DA Access Report

21183

10-14 Lethbridge Street, Penrith, NSW

# ACCESS REPORT

[Image description: Plan of Basement above shows the provision of Accessible parking spaces]

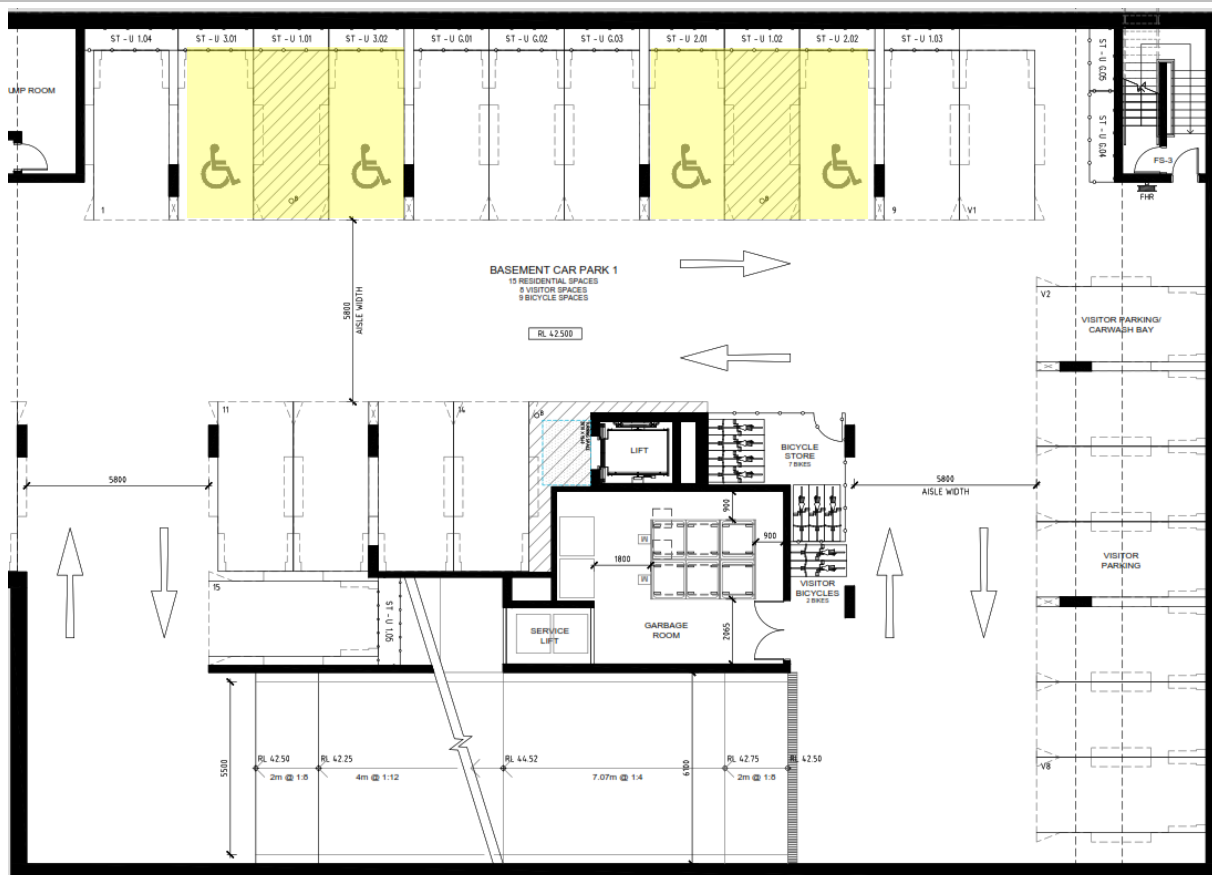
<b>Compliance Comments</b>	<p>Complies</p> <p>Penrith Council requires provision of 10% Adaptable units in the development.</p> <p>Development has total number of 36 units. 10% of 36 = 4 required Adaptable units.</p> <p>Therefore, 4 accessible carparking spaces are required for the residential component of the development.</p> <p>4 Accessible car parking spaces have been provided in development.</p> <p>One accessible/ parking space is required to be allocated to each of the Adaptable units.</p>

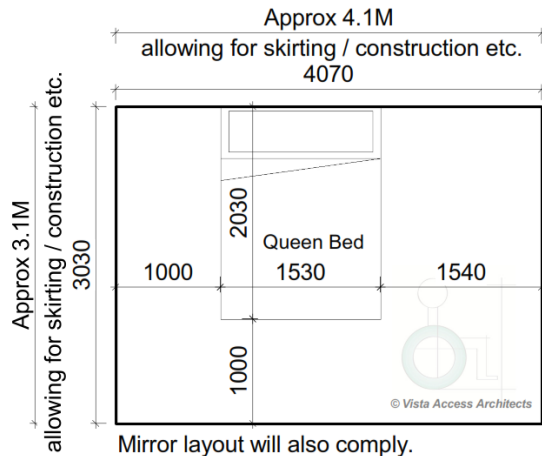
The units designated as adaptable are unit numbers 2.01, 2.02, 3.01 and 3.02

At DA stage there is insufficient information to certify compliance with the Standard, however, in accordance with the table below, the nominated units can comply with the spatial requirements of AS4299 for Adaptable Housing.

**Units 4 03 and 5 03 shown below**

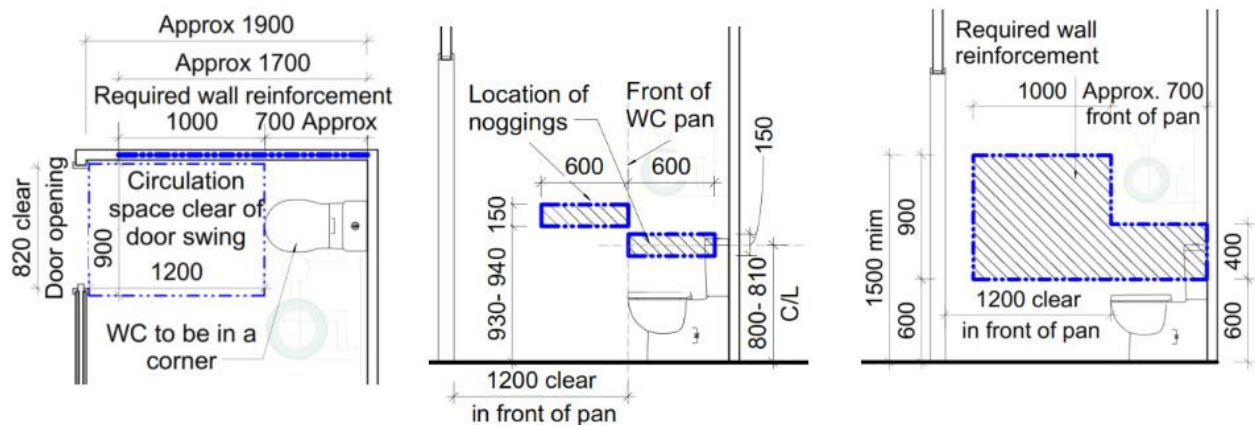
The following 8 units **4.01, 4.02, 4.03, 4.04, 5.01, 5.02, 5.03 and 5.04** are capable of providing compliance with the features of Silver level of Livable Housing Guidelines as noted in the table below.

- Note that ALL internal passageways are required to be 1M clear when measured from skirting to skirting so allow for the same.
- Note that the wet areas are to be such that flush transition is available. One way of achieving this is to recess the floor slab.
